UNITED STATES  
NUCLEAR REGULATORY COMMISSION  
WASHINGTON, D.C. 20555-0001

SUBJECT: CLASSIFICATION OF HANFORD LOW-ACTIVITY TANK WASTE FRACTION

**REPORT ON  
DOE HANFORD TANK WASTE CLASSIFICATION**

Figure 2-1. Estimate Hanford Site Tank Waste Radionuclide Inventory<sup>cd</sup>

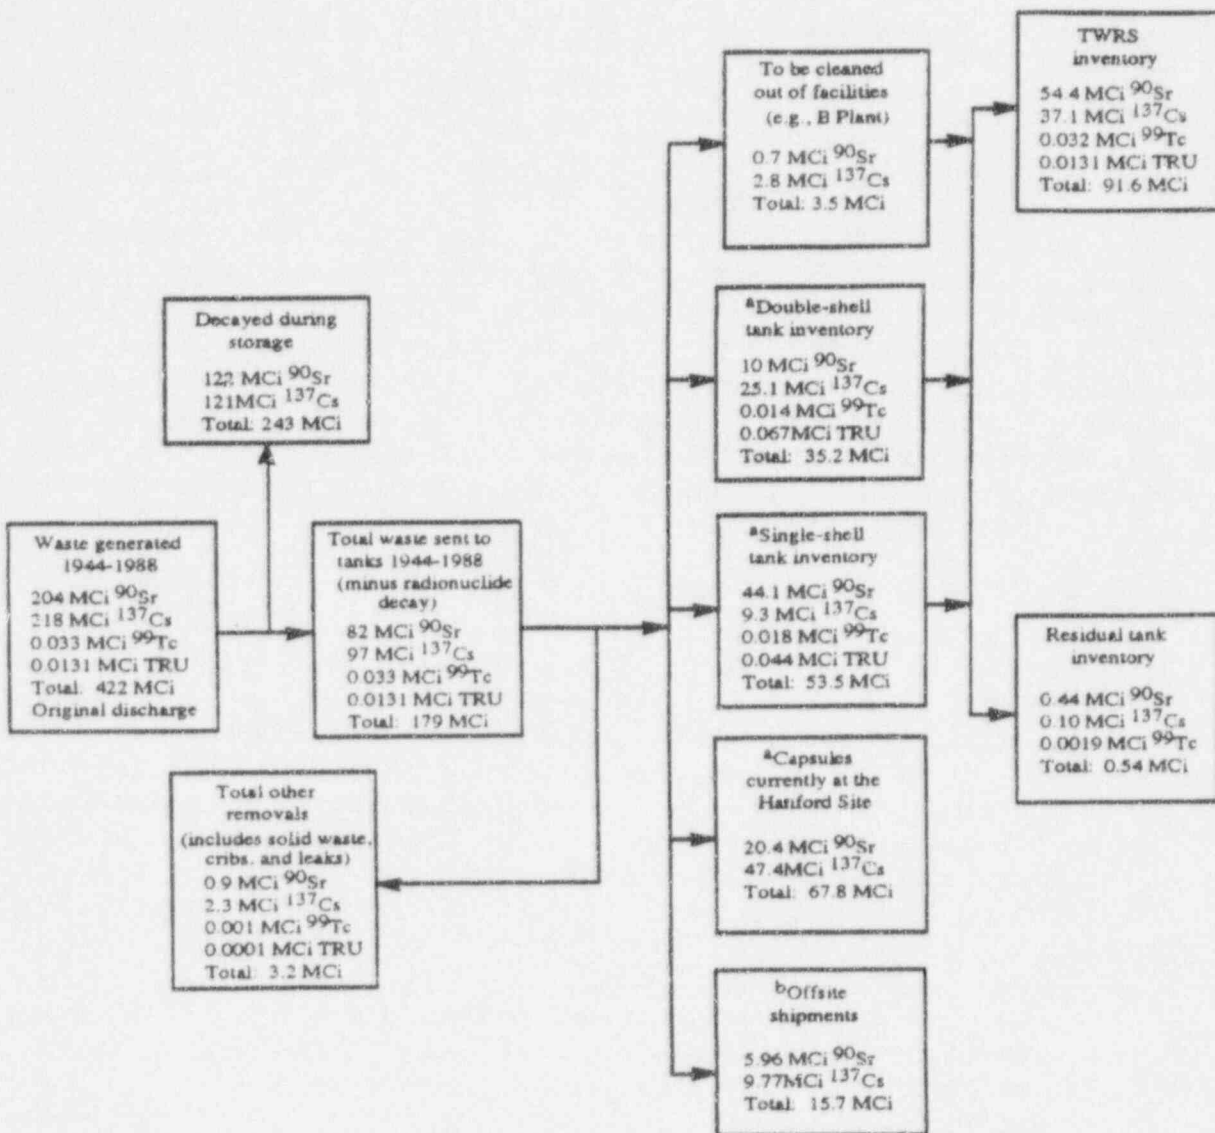
Figure 2-1, reproduced from the TBR (Westinghouse Hanford Company, 1996a, p. 3-2, figure 3-1), provides the estimated material balance for the Hanford Site tank waste radionuclide inventory. Figure 2-1 indicates that 243 MCi of the original tank waste radionuclide content of 422 MCi will have decayed by the year 1999. This value reflects the relatively short half lives of  $^{137}\text{Cs}$  and  $^{90}\text{Sr}$ . The material balance also indicates that approximately 87 MCi are accounted for as (i) leaks or deliberate discharges, (ii) encapsulation of  $^{137}\text{Cs}$  and  $^{90}\text{Sr}$ , (iii) other offsite shipments, or (iv) residual tank inventories. The remaining 91.6 MCi consists of 55.6 MCi insoluble waste to be disposed in a geologic repository as HLW and 36 MCi that comprises the soluble radionuclides that will be further treated to produce what DOE proposes to classify as incidental waste. This 36 MCi contains most of the  $^{137}\text{Cs}$  and  $^{99}\text{Tc}$  and almost all of the  $^{76}\text{Se}$ ,  $^{129}\text{I}$ ,  $^{14}\text{C}$ , and  $^3\text{H}$  (Westinghouse Hanford Company, 1996a, p. 4-1). After further treatment, 8.5 MCi will remain as incidental waste with 27.5 MCi being added to the HLW stream.

As shown in figure 2-1 of this report, 91.6 MCi comprises the Hanford Site tank waste inventory that will be processed for disposal as HLW or LLW. Approximately 99.9 percent of this waste is  $^{137}\text{Cs}$  or  $^{90}\text{Sr}$ . Initially, a simple solids-liquids separation will be performed on this waste to yield a low-activity liquid fraction containing the bulk of the nonradioactive materials, including about 3 percent solids carryover, and a high-activity fraction containing most of the solids. This solids-liquids separation process is expected to be relatively simple to complete and will remove approximately 55.6 MCi, consisting primarily of  $^{90}\text{Sr}$  and TRU radionuclides (Westinghouse Hanford Company, 1996a, pp 3-2, 4-1, 4-2). Chapter 5 of the TBR concludes that, with the additional selective removal of transuranic wastes from three complexant concentrate tanks, and single-cycle ion exchange removal of  $^{137}\text{Cs}$  from certain wastes,
